MFN 06-466 Supplement 1

Subject: **Response to Portion of NRC Request for Additional Information
Letter No. 79 - Passive Containment Cooling System - RAI Number
6.2-102 S01**

RAI Number 6.2-102 S01

Figure 2.15.4-1. Passive Containment Cooling System Schematic

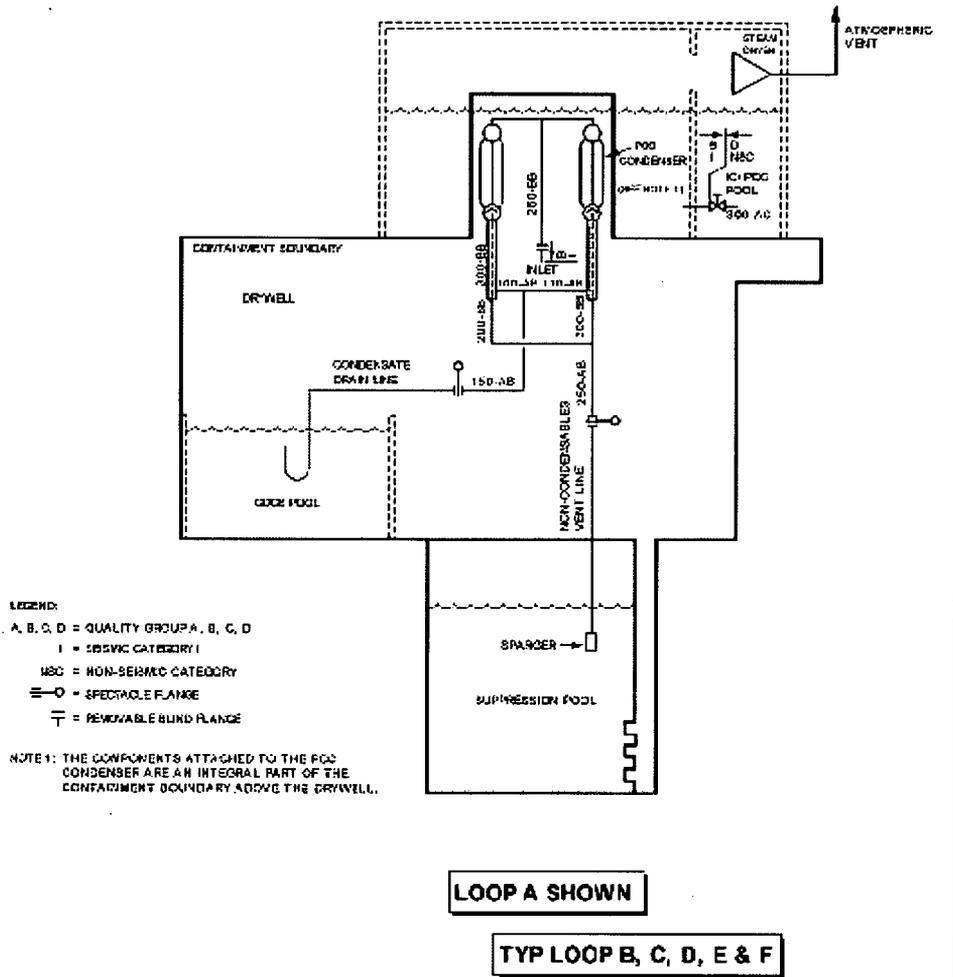
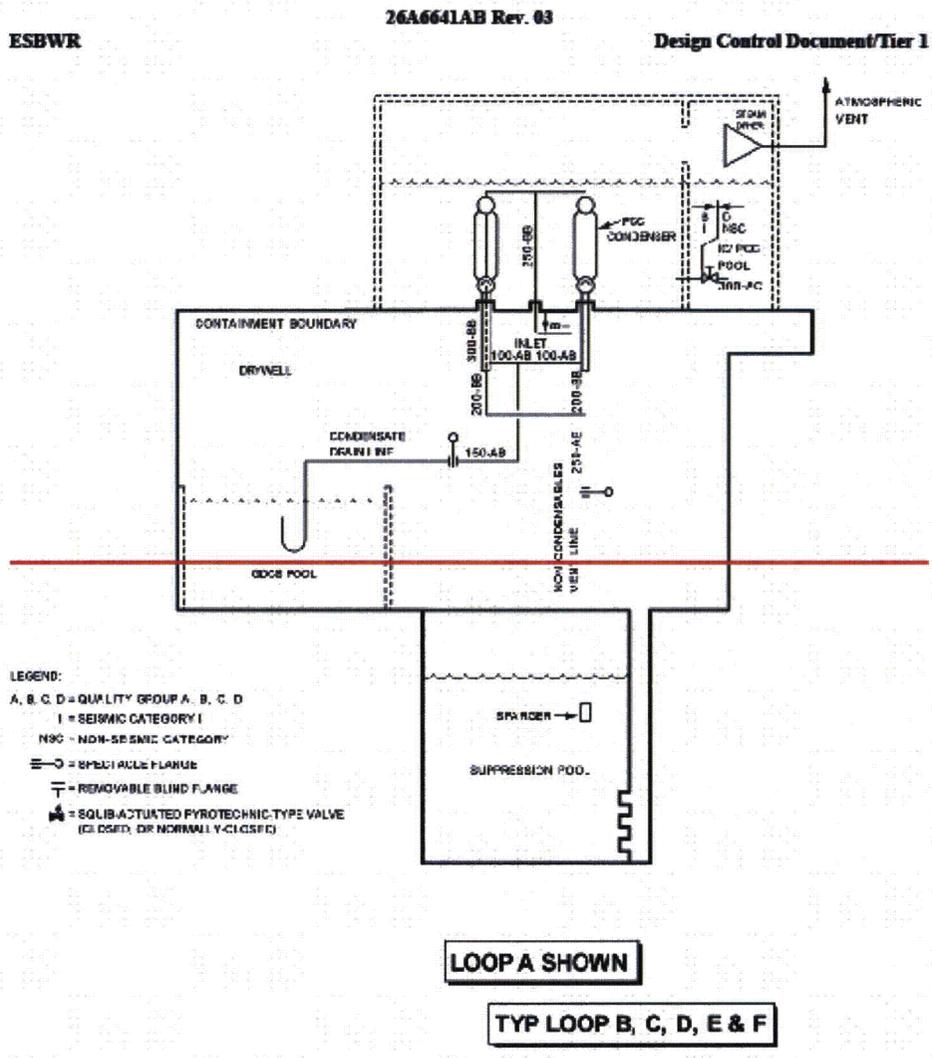
Provide additional justification for the current design of the PCCS, or revise the DCD with a redesign of the system to include CIVs, per the NRC's applicable regulatory position.

An extensive review of the DCD has been performed to standardize the description of the PCCS as being an integral part of the containment boundary. These descriptions will be revised in both DCD Tier 1 and DCD Tier 2 to correct all inconsistencies.

- Tier 1, Subsection 2.15.4
- Tier 1, Table 2.15.4-1
- Tier 1, Figure 2.15.4-1
- Tier 2, Figure 1.1-2
- Tier 2, Subsection 1.2.2.15.4
- Tier 2, Table 1.3-2
- Tier 2, Sections 3.1 and 3.8
- Tier 2, Table 3.2-1
- Tier 2, Subsection 3.9.3
- Tier 2, Section 6.2 and Subsection 6.6.1
- Tier 2, Tables 6.2-10 and 6.2-47
- Tier 2, Figures 6.2-1, 6.2-15, and 6.2-16
- Tier 2, Subsections 7.1.5 and 7.3.2
- Tier 2, Subsections 9.1.6 and 9.2.5
- Tier 2, Subsection 15.5.6
- Tier 2, Subsection 16.3.6.1.7, 16B.3.6.1.7, and 16B.3.7.1
